FURTHER REPORT TO SYDNEY WEST JRPP

JRPP No	
DA Number	DA/601/2013
Local Government Area	Parramatta City Council
Proposed Development	Tree removal, re-subdivision and construction of a residential flat building complex containing 157 apartments along the Mobbs Lane frontage of the site.
Street Address	Part Lot 1 and Lot 11 DP 270605 Midson Road (former Eastwood Brick Pit), EASTWOOD

Figure 1: Before and after sections showing natural ground line, height control and view lines from Mobbs Lane and Carrington Avenue for building A.

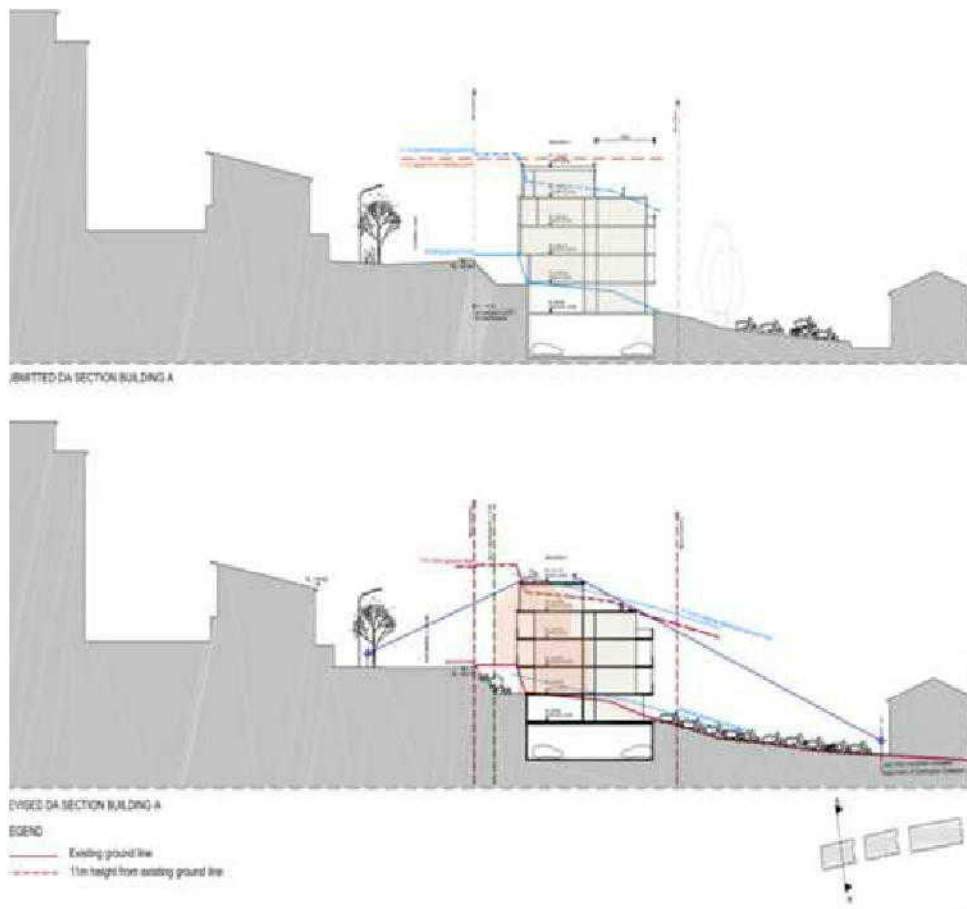
- The internal floor to floor levels within the building are reduced to 3.0m (meeting the requirements of the RFDC). As a result the height of the building is now within the 11 metre height plane as viewed from Mobbs Lane;

The upper level of Building A continues to exceed the overall height plane as shown on the section plus the isolated lift overrun. The highest point of this building is 14.1 metres. This is a variation of 3.1 metres or 28% on the 11 metre height control and is a 0.4 metre reduction on the most recently considered proposal. This is a reduction in height from the previous submission as follows:

Figure 5: Before and after sections showing natural ground line, height control and view lines from Mobbs Lane and Carrington Avenue for building C.

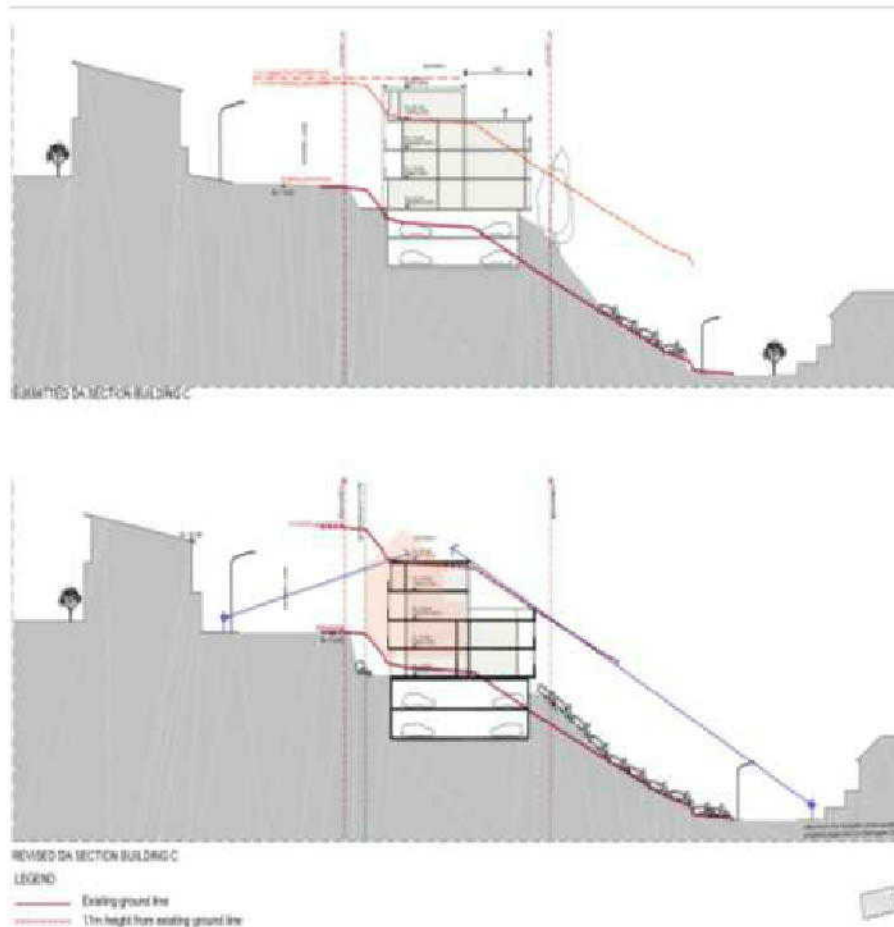
- Deletion of 5 units reducing bulk to the Carrington Crescent properties to the south;
- Reduction in basement parking levels for the building allowing a lowering of the overall building height by 2.4m;
- An increased 1m setback on the southern elevation with associated reconfiguration of unit types on that elevation and an overall setback of the building away from the town houses on Carrington Crescent;
- Level 4 of the building C has been further setback along the eastern portion of that upper level to again reduce bulk and scale as perceived from Carrington Crescent;
- The floor to floor levels within the building have been marginally reduced to 3.0m (meeting the requirements of the RFDC) and now reducing the height of the building to be within the 11 metre height plane as viewed from Mobbs Lane;

The view line drawn from the southern side of Carrington Crescent to the 11 metre height plane at the top edge of the southern elevation demonstrates that the building does not present any significant additional height projecting outside the height plane. The building largely sits within the statutory height plane and meets the view requirements of the Panel.

Figure 7: Before and after sections showing natural ground line, height control and view lines from Mobbs Lane and Carrington Avenue for building D.

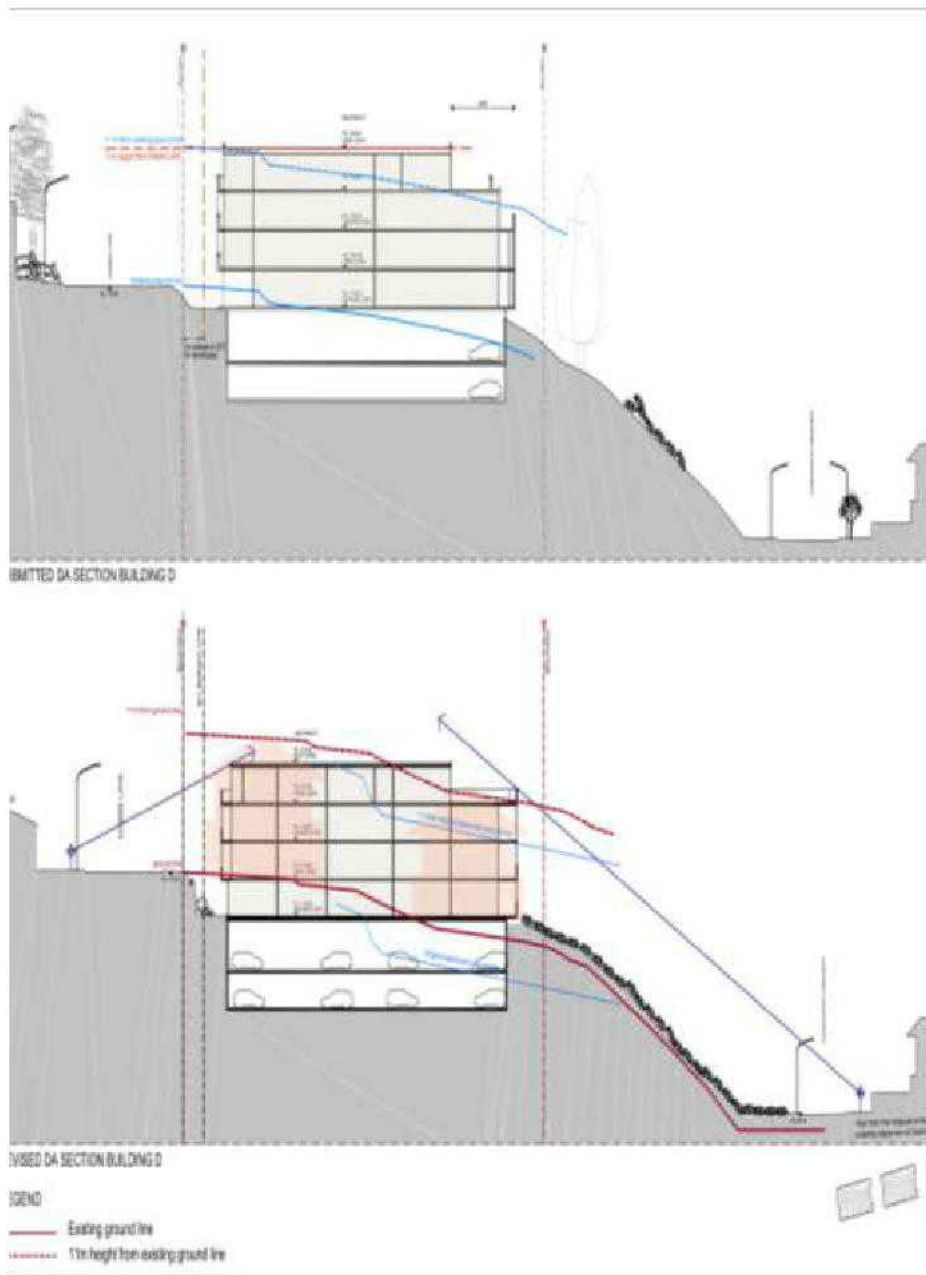
- Deletion of 3 units at the upper southern to reduce bulk to the Carrington Crescent properties to the south;
- A review of building planning and in particular the basement parking levels for the building has allowed a lowering of the overall building height by 1.3m;
- The floor to floor levels within the building have been marginally lowered to 3.0m (meeting the requirements of the RFDC), reducing the height of the building to be within the 11 metre height plane as viewed from Mobbs Lane;
- The upper level of the northern units have been setback a further 1 metre from the southern side to again reduce the visual impact to the Carrington Crescent properties;

As shown on the section, the view from Mobbs Lane is of a 3 to 3½ storey building with its northern elevation at or below the 11 metre statutory height plane. As the building stretches to the rear it extends outside the height plane but this is not viewed from the Mobbs Lane view location. The building therefore offers a height that meets the principles recommended by the Panel.

The southern elevation of Building D presents as a three storey building to Carrington Crescent. The overall height of the building at the rear elevation is marginally in excess of the 11 metre height plane with the height penetration as shown in cross section limited to an upper level balustrade. As shown on the cross section the bulk of the building is setback and is generally not viewed from Carrington Crescent. The amended design meets the principle as recommended by the Panel.

Figure 5: 3-D view plane analysis from Carrington Crescent.

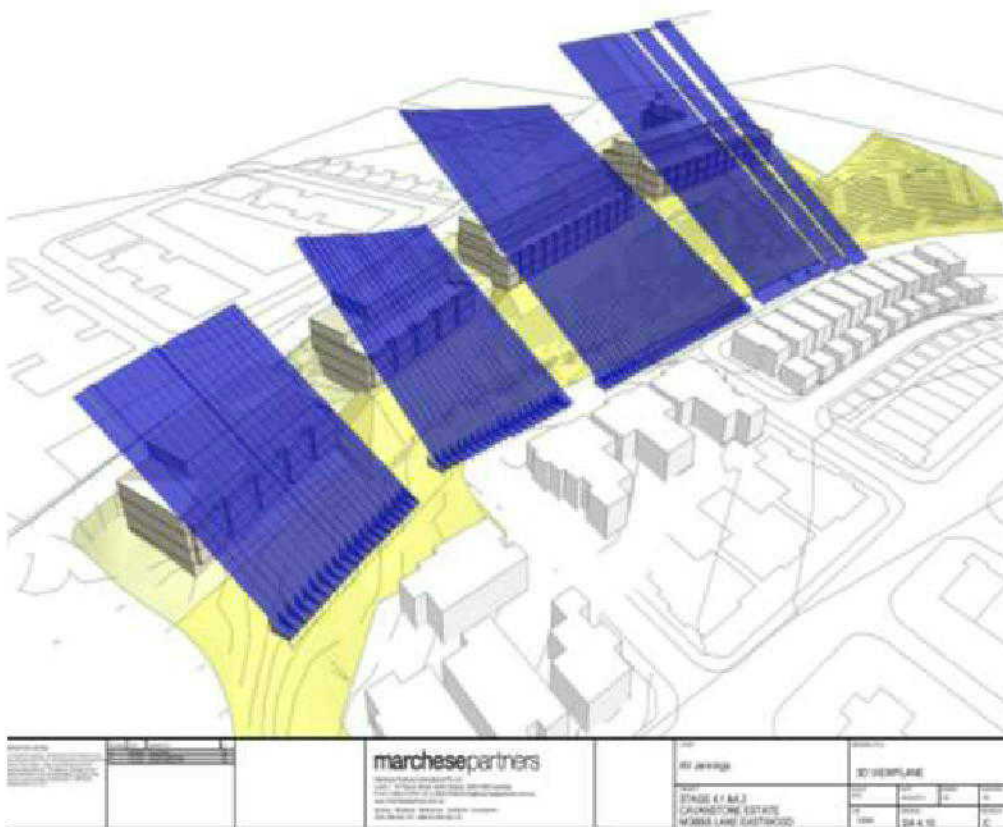
The entire project has been modelled and has been analysed in terms of the view plane from the footpath on the southern side of Carrington Crescent. (See dwg 4.10 attached).

This shows a viewing point consistent with the southern side of Carrington Crescent (or adjacent to the side fence of the housing relative to Building A), looking up perpendicular to the buildings above. The view picks up the closest top point of the building (which in all cases is at or below the 11 metre statutory height limit) and shows that no other point of the building behind, is visible along this view line from the footpath on Carrington Crescent.

This diagram demonstrates that a person standing on the footpath in Carrington Crescent will be unable to see any part of the building that extends above the maximum building height of 11m. This conforms to the recommendation of the Panel.
